CITY OF ALBUQUERQUE

RE: 2440 Louisiana Office Bldg
Conceptual Grading & Drainage Plan
Engineer's Stamp Date: 01/17/22
Hydrology File: H19D084

Based upon the information provided in your submittal received 01/21/2022, the Conceptual Grading & Drainage Plan **is not** approved for action by the DRB on Site Plan for Building Permit. The following comments need to be addressed for approval of the above referenced project:

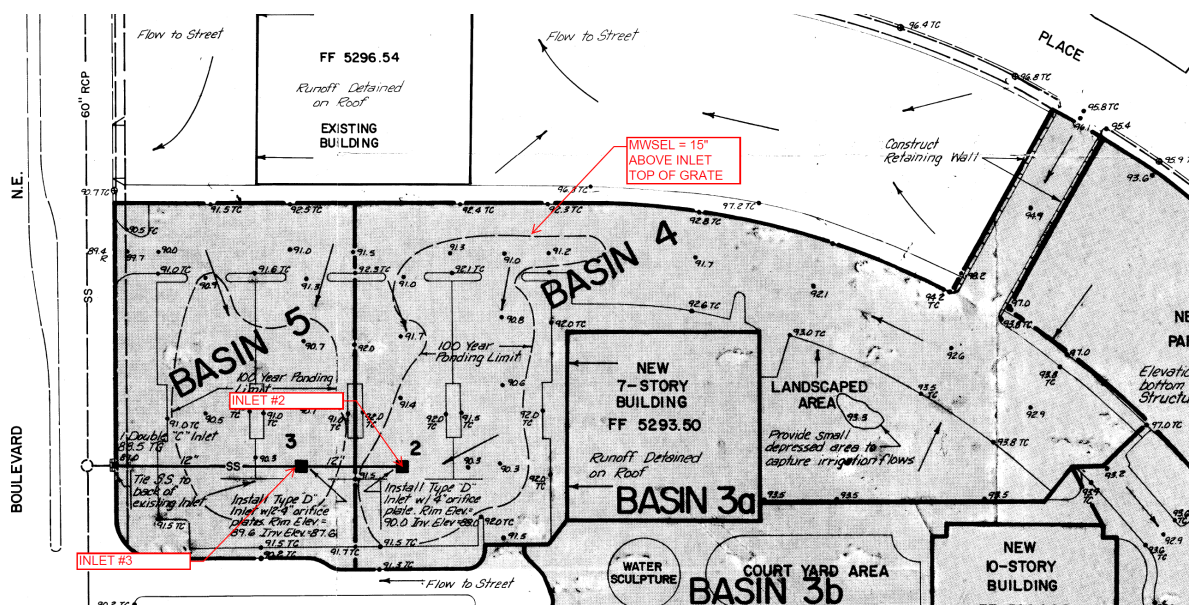
1. Under Existing Conditions, reference to prior drainage file H16-D1 is inaccurate. The actual drainage file is H19D084. According to this drainage plan, this site has limited discharge. See attached plan and calculations.
2. Below is an image of the existing parking with two ponding area utilizing the parking and adding about 15 inches above the inlets to store the detention volume.

Since it looks like a large portion of detention basin #5 is being removed, an underground system will have to be utilized and outfall to the existing inlet on Louisiana. Also, since Basin #4 ties into Basin #5, Basin #4 will also have to be re-evaluated to determine that it can still provide the required detention.
